**Agenda Item 3**  
**City of Lake Forest Fire Station Renovation**  
**255 W. Deerpath**

**Agenda Item 4**  
**916 Oakwood Avenue**  
**Building Scale Variance for an Open Front Porch,**  
**First and Second Floor Additions**  
**and Detached Garage**

## 916 Oakwood Avenue

**Consideration of a request for approval of demolition of an existing rear one story element, a building scale variance for an open front porch, two rear additions, and expansion of second floor space. A detached garage is also proposed.**

PROPOSE SITE PLAN / LANDSCAPE

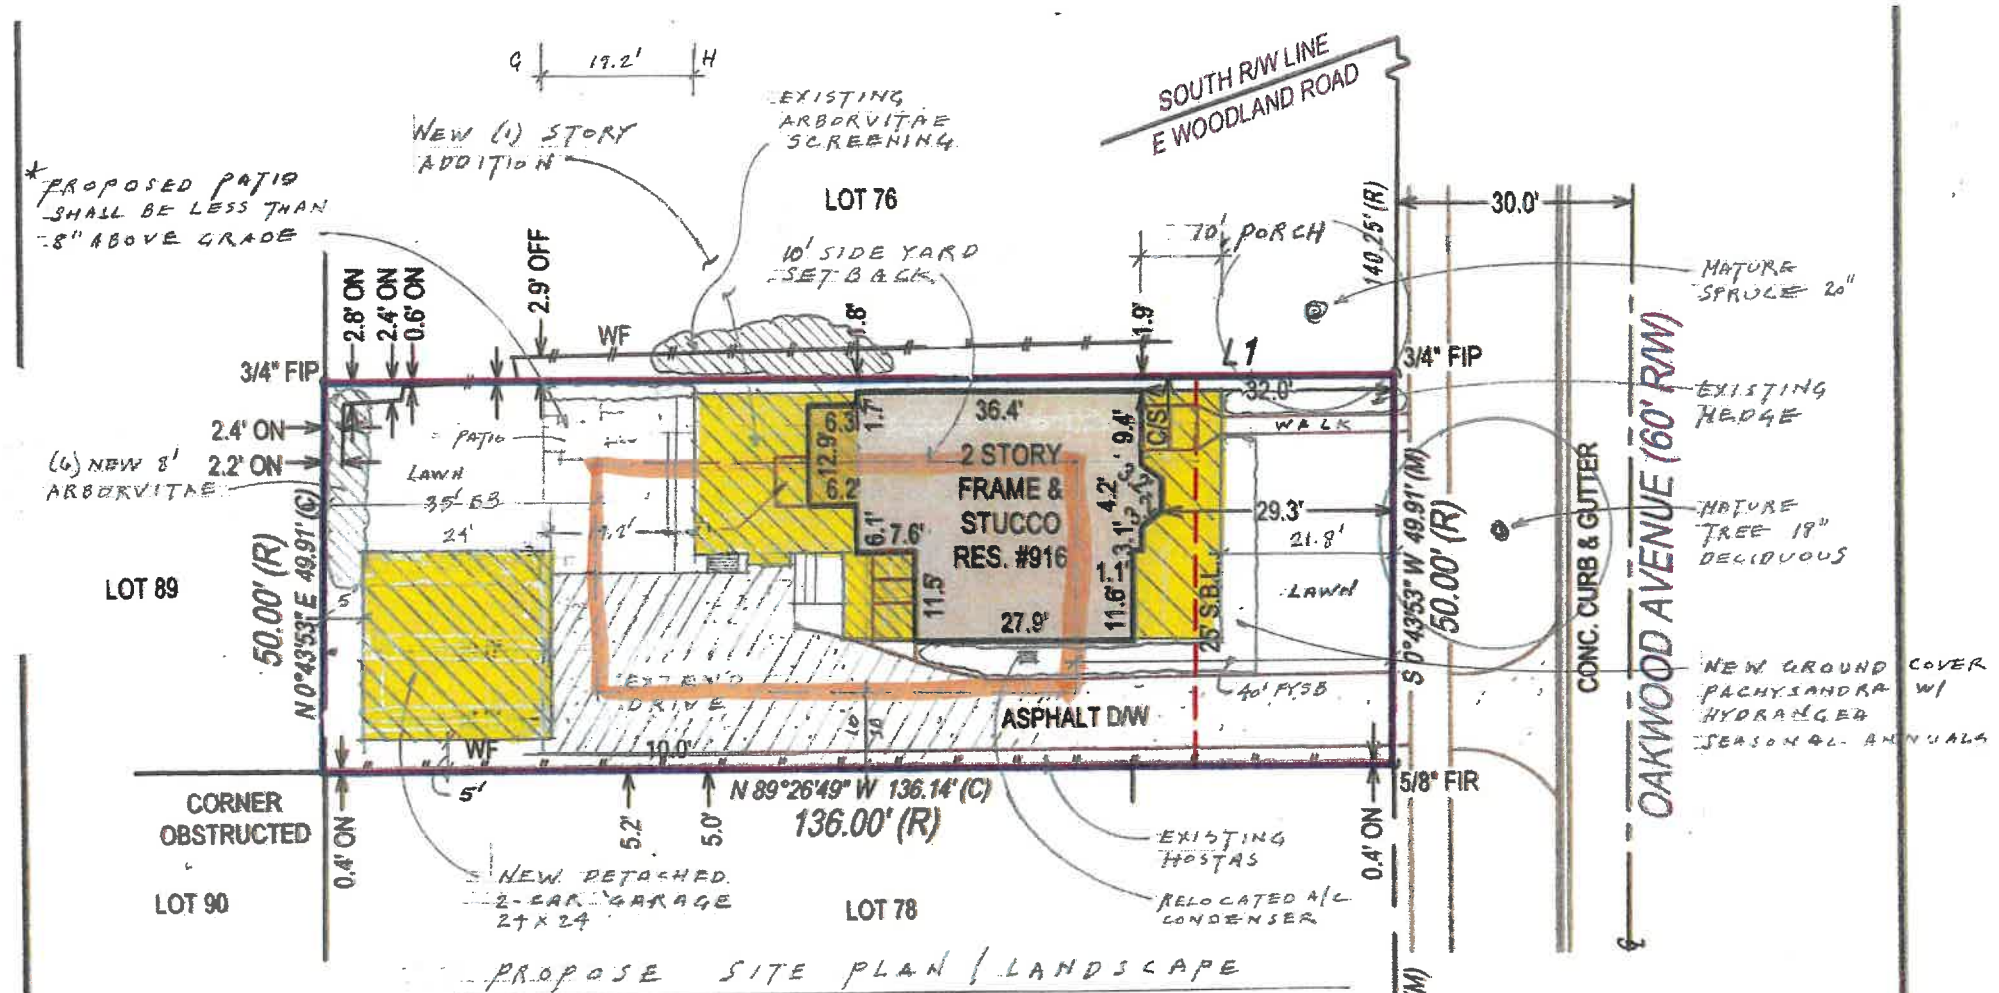
A conceptual landscape plan, with limited detail, is included in the Board's packet.

Any trees planned for removal should be identified in the final landscaping plan. Replacement inches for the trees removed will be determined pending submittal of a detailed plan showing existing trees and trees planned for removal.

The final landscape plan should detail foundation plantings at the base of the proposed open front porch and plantings along the north property line to the extent possible.

**Staff Recommendation:** A detailed landscape plan should be submitted with the building permit application and plans and will be subject to review and approval by City staff.

- PROPOSED GARAGE -  
916 BARWOOD LF

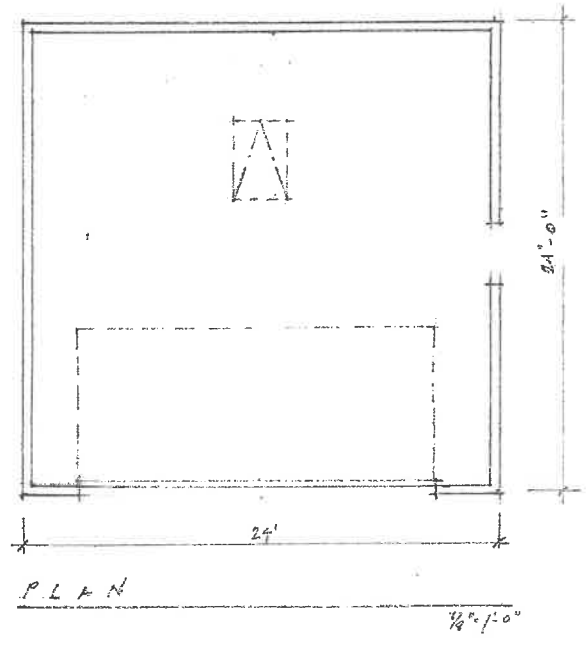
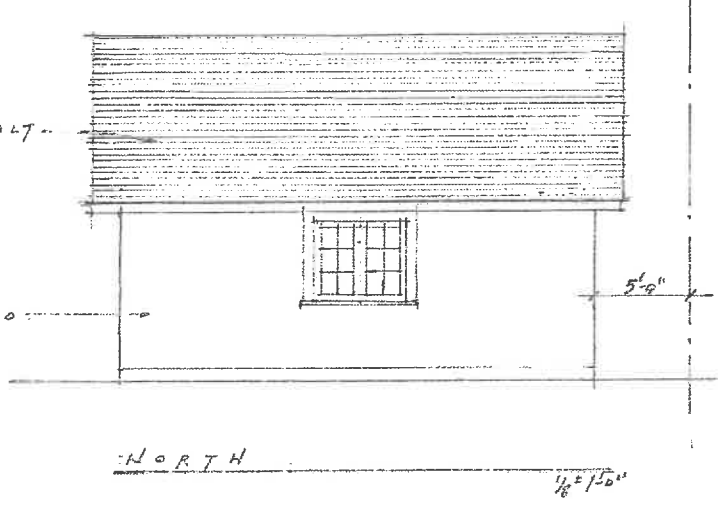
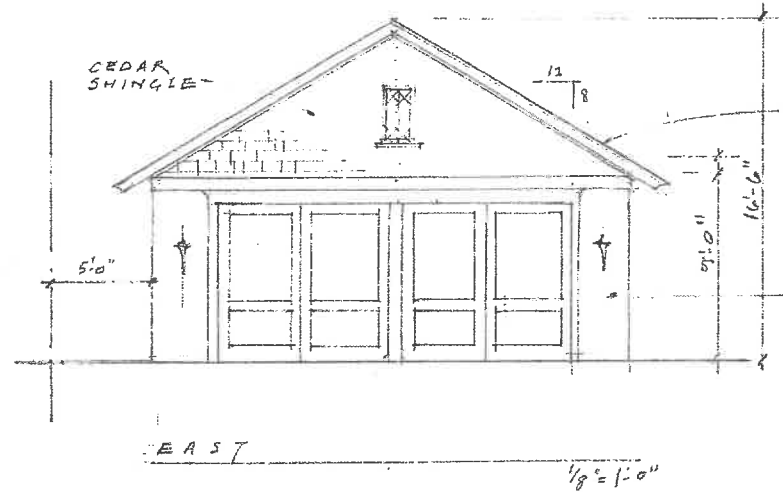
The garage features a gabled roof with a decorative window relating to the gable roof forms on the residence. Two garage doors are proposed, details are needed on the height, width, style, and material. Plans submitted for permit must include south and west elevations of the garage. The north elevation shows a centrally located window. The design is consistent with the character and details of the existing residence.

**Staff Recommendation:** Provide all elevations of the garage including details on the garage doors.

**Staff Comment:** Material samples and a complete color palette should be presented at the Board meeting. Details on the material and style of the garage doors are required.

PROPOSED NORTH  
1/8" = 1'-0"

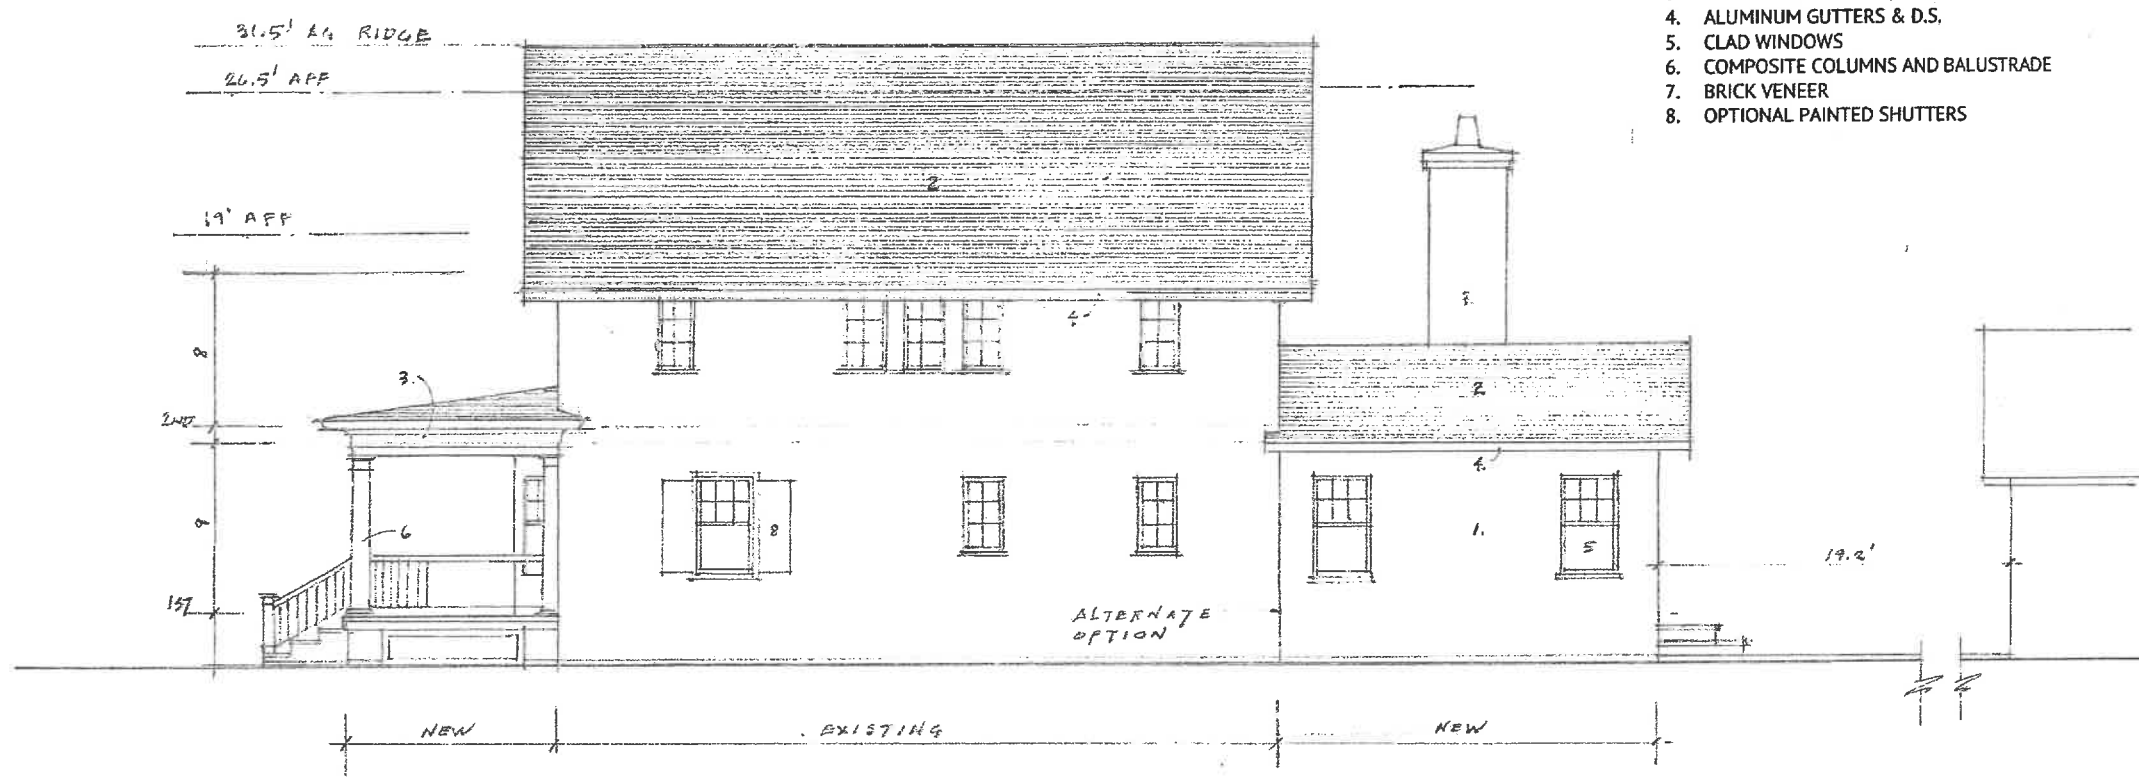
**Staff Recommendation:** Recommend approval of the stepped in massing for the rear addition located at the northwest corner of the residence to provide minimal space between the addition and the north property line, to break up the length of the north elevation, and to facilitate construction and future maintenance.

1. The plans submitted for permit shall reflect the stepped in configuration of the single story rear addition at the northwest corner of the house. The footprint of the addition shall not encroach further to the north than the footprint of the existing single story structure to be removed.
2. The front porch shall remain open.
3. All modifications to the plans including those made in response to Board direction or discussion and those made as the result of final design development shall be clearly called out on the plans submitted for permit. Staff is directed to review any changes, in consultation with the Chairman as appropriate, to verify that the plans as presented are consistent with the Board's approval.
4. Prior to the issuance of a building permit:

**SHEET TITLE:**  
**Site Plan**

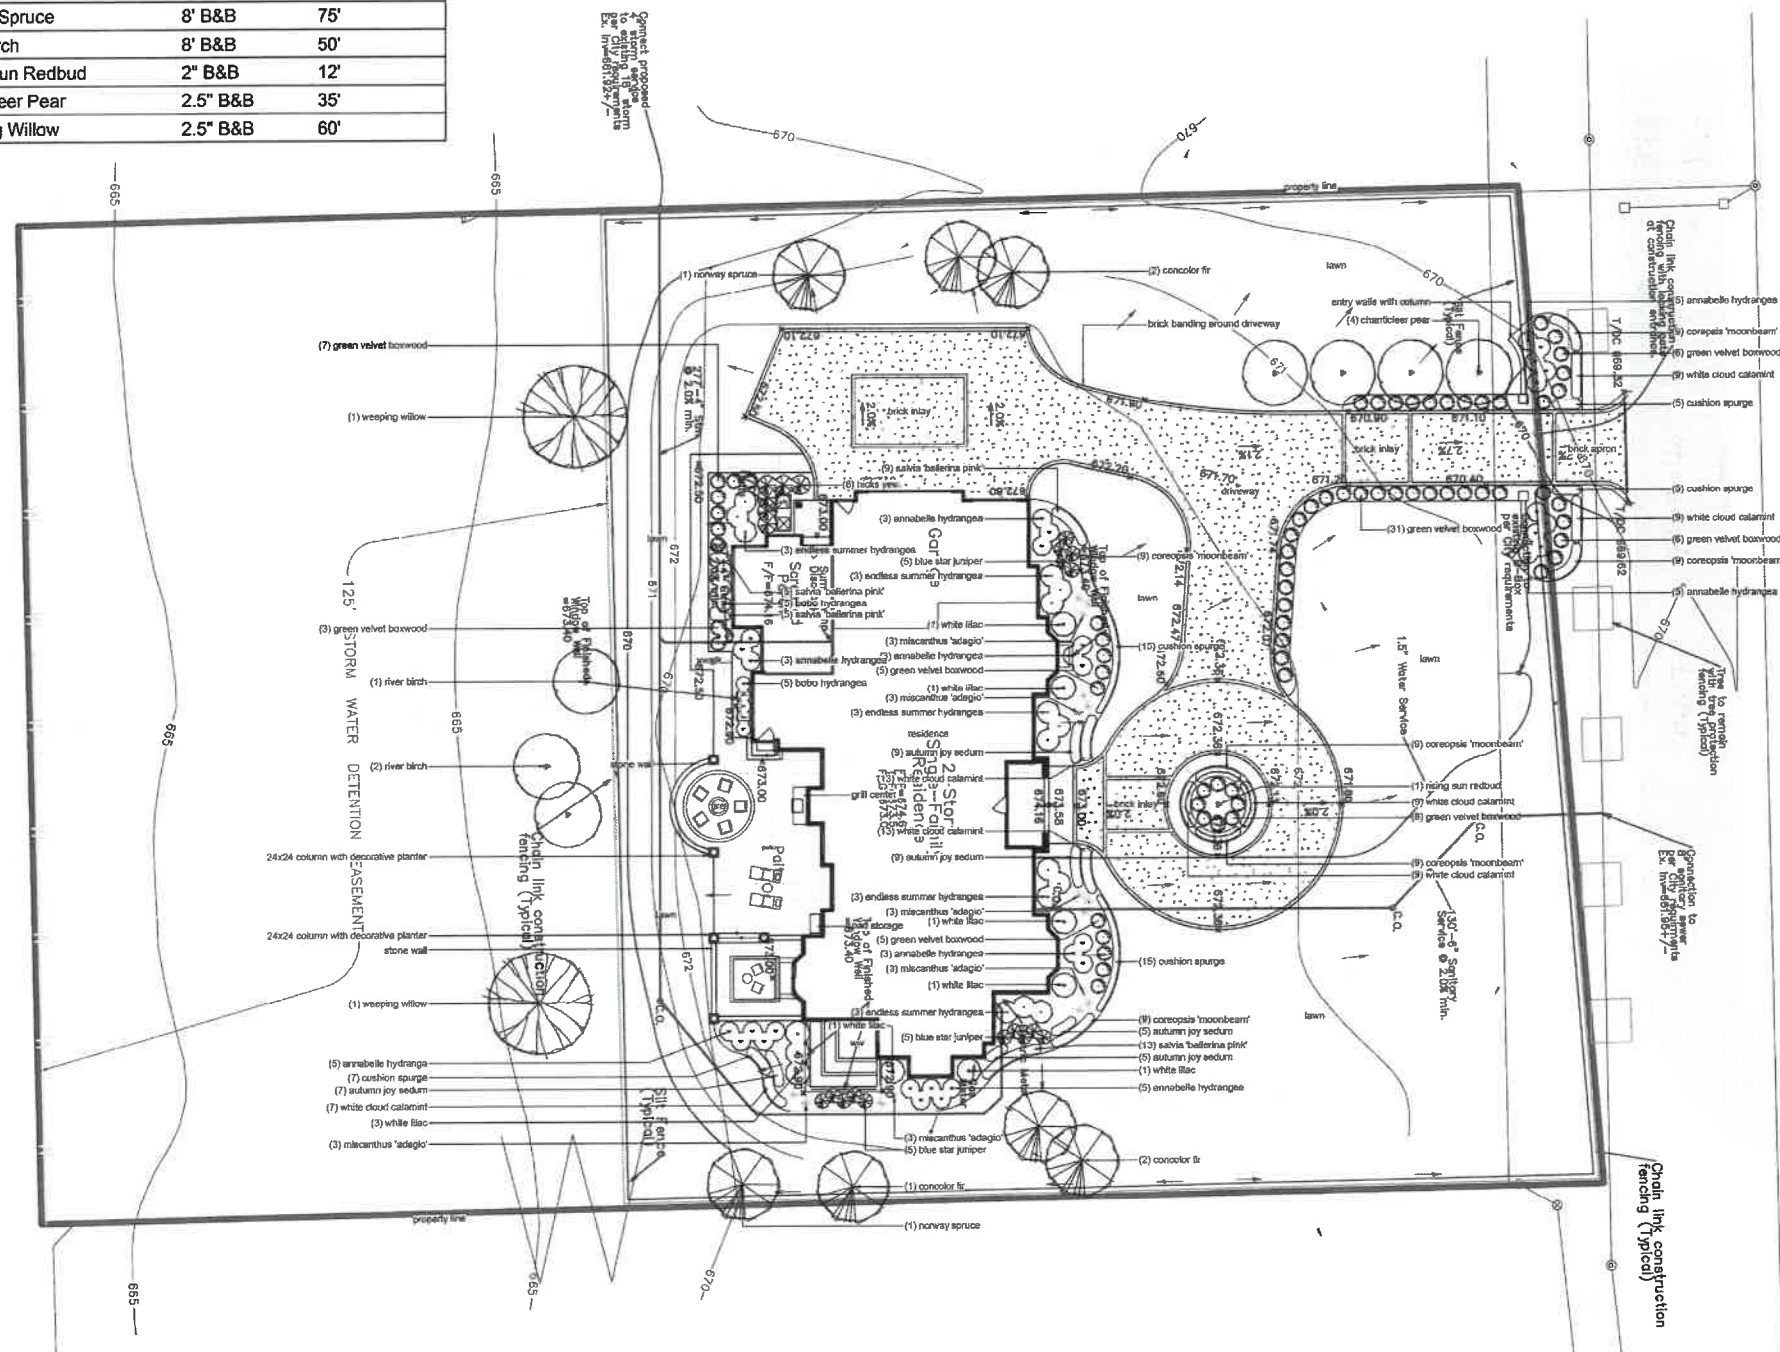
As noted above, improvements, including planting, is prohibited in the 125-foot stormwater detention easement located in the rear yard without prior approval from the City Engineer. Limited plantings at the north and south edges of the detention easement may be permitted at the discretion of the City Engineer after a determination that the stormwater capacity of the easement will not be impacted. Four trees are currently proposed in the detention easement. Existing vegetation is located along the south edge of the detention easement along with a chain link fence in poor condition. A neighbor to the south requested that to the extent possible, some vegetation is retained or planted along the south property line to maintain some screening. The neighbor also requested clean up of the area including attention to the deteriorating fence and removal of debris.

The plan proposes four understory or ornamental trees and four evergreen trees and foundation plantings on every elevation. Additional plantings should be reflected on the final landscape plan opposite the garage to provide screening of a future neighboring residence.

**Staff Recommendation:** Clearly indicate all trees that will be impacted by construction on the plans submitted for permit.

- a. Plantings are not permitted in the rear stormwater detention easement unless approved by the City Engineer. Clearly indicate all trees that will be impacted by construction on the plans submitted for permit.
- b. Prepare a final landscape plan that fully meets Code requirements for new residences and provides screening along properties lines including but not
